## I2C Errata 1

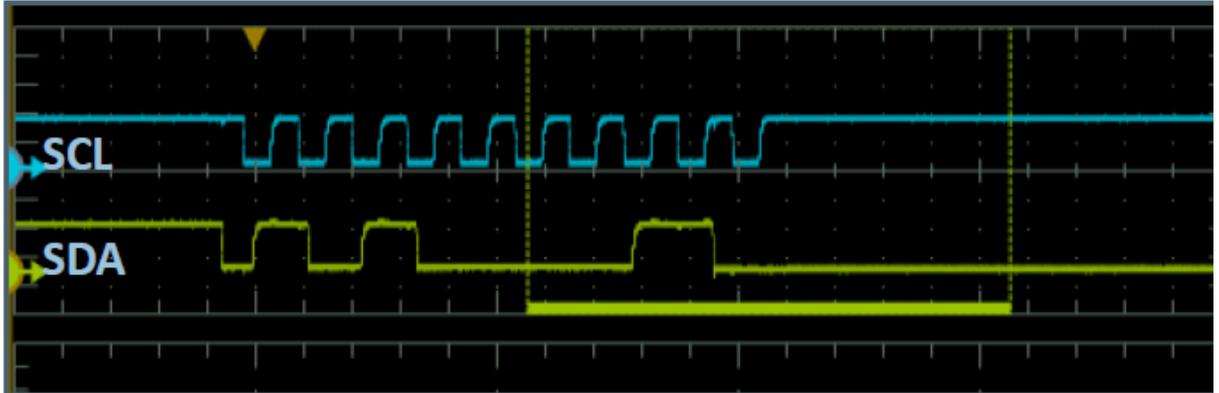
- A. The errata applies to ADuCM350 1p0, 1p1 and 1p2 silicon.
- B. Anomaly: I2C bus hangs when configured as slave Tx
- C. Description:

During a read from the master to slave, if the slave's FIFO is empty, the slave should NACK the master's request. Then it should release the bus allowing the master to generate a STOP condition. In the case of the slave's FIFO buffer being empty, if data is loaded when the ninth SCL clock is high, the slave generates an ACK to the master and the MSB of read data is sent on the following SCL positive edge. If the MSB is 0, the SDA line will be held low and the slave will wait for extra SCL clocks to transmit the remaining bits. When this happens, the I2C master detects a NACK and then generates a STOP condition. Master arbitration is lost due to the SDA line being indefinitely low.

- D. Workarounds:
  1. Placing valid data in the Slave Tx FIFO.
  2. Set the BUS\_CLR\_EN bit in the I2CMCON register. If this bit is set, the master will initiate a Bus-Clear operation by sending up to 9 extra SCL cycles.
  3. Set EARLYTXR bit in the I2CSCON register. Setting this bit enables a transmit request just after the positive edge on the SCL line during the read bit transmission.
  4. Resetting the slave interface by disabling/enabling the slave.

## I2C Errata 2

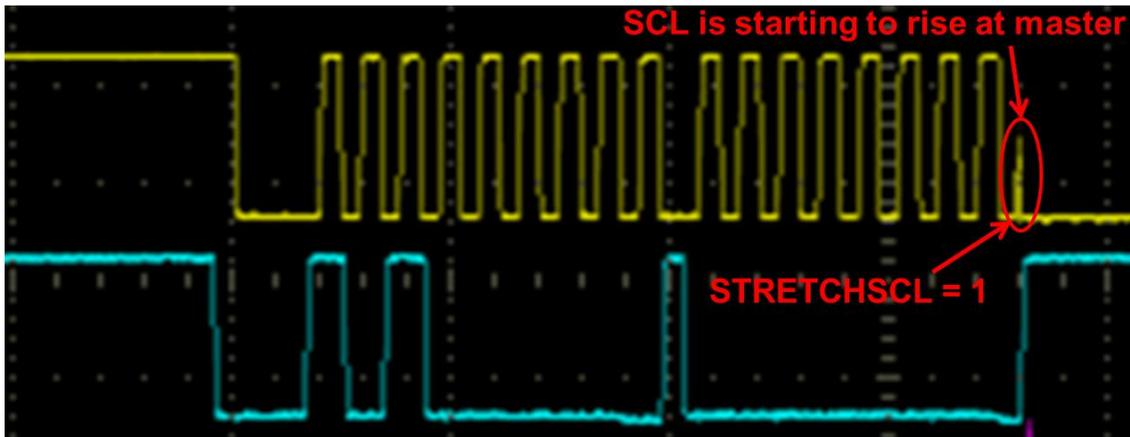
- A. The errata applies to ADuCM350 1p0, 1p1 and 1p2 silicon.
- B. Anomaly: I2C master fails to operate when the sum of the values in HIGH and LOW in the I2CDIV register has a value of less than 18 (0x12).
- C. Description: In an attempt to minimize the power consumption of the I2C interface, it may be desirable to set the PCLK frequency to 1MHz and set the SCL frequency to 100kHz. Using the provided formula, this would lead to the following HIGH and LOW values in the I2CDIV register:  
$$\text{HIGH} = (\text{REQD\_HIGH\_TIME} / \text{PCLK\_PERIOD}) - 2$$
$$\text{HIGH} = ((10\mu\text{s} / 2) / 1\mu\text{s}) - 2$$
$$\text{HIGH} = 3$$
$$\text{LOW} = (\text{REQD\_LOW\_TIME} / \text{PCLK\_PERIOD}) - 1$$
$$\text{LOW} = ((10\mu\text{s} / 2) / 1\mu\text{s}) - 1$$
$$\text{LOW} = 4$$

When these values are programmed, the I2C master will not function.
- D. Workarounds:
  - 1. Use the `adi_I2C_SetMasterClock()` function to set the SCL frequency. Ensure to check for a valid return code.
  - 2. Do not program values to the HIGH and LOW fields in the I2CDIV register which give a sum of less than 18 (0x12).
